UNITED STATES ENVIRONMENTAL PROTECTION AGENCY
REGION IX

**Re: Toxic Substances Control Act, Polychlorinated Biphenyls – Application Under 40 CFR
761.61(c), Former Ross Valley Sanitary District Waste Water Treatment Plant, Larkspur, CA**

**U.S. Environmental Protection Agency Region 9
TSCA Conditional PCB Cleanup Approval Under 40 CFR 761.61(c)**

Former Ross Valley Sanitary District Waste Water Treatment Plant
2000 Larkspur Landing Circle, Larkspur, California

ILS ASSOCIATES, INC. 1000 LARKSPUR LANDING CIRCLE LARKSPUR, CA 94043-2000 TEL: (415) 253-1000 FAX: (415) 253-1001	
ROSS VALLEY SANITARY DISTRICT 2000 LARKSPUR LANDING CIRCLE LARKSPUR, CA 94043-2000 TEL: (415) 253-1000 FAX: (415) 253-1001	TOPOGRAPHIC MAP SHEET NO. 1 OF 1

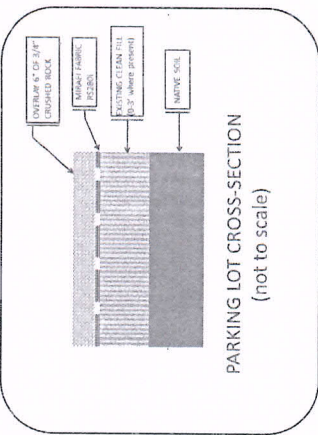
EPA concurs with the short-term land use proposed by RVSD in the Application for the Phase 1 Site with the conditions established below. The attached figure identifies the Phase 1 Site. In addition, Table F.1 in Section F of this Approval provides the schedule of deliverables.
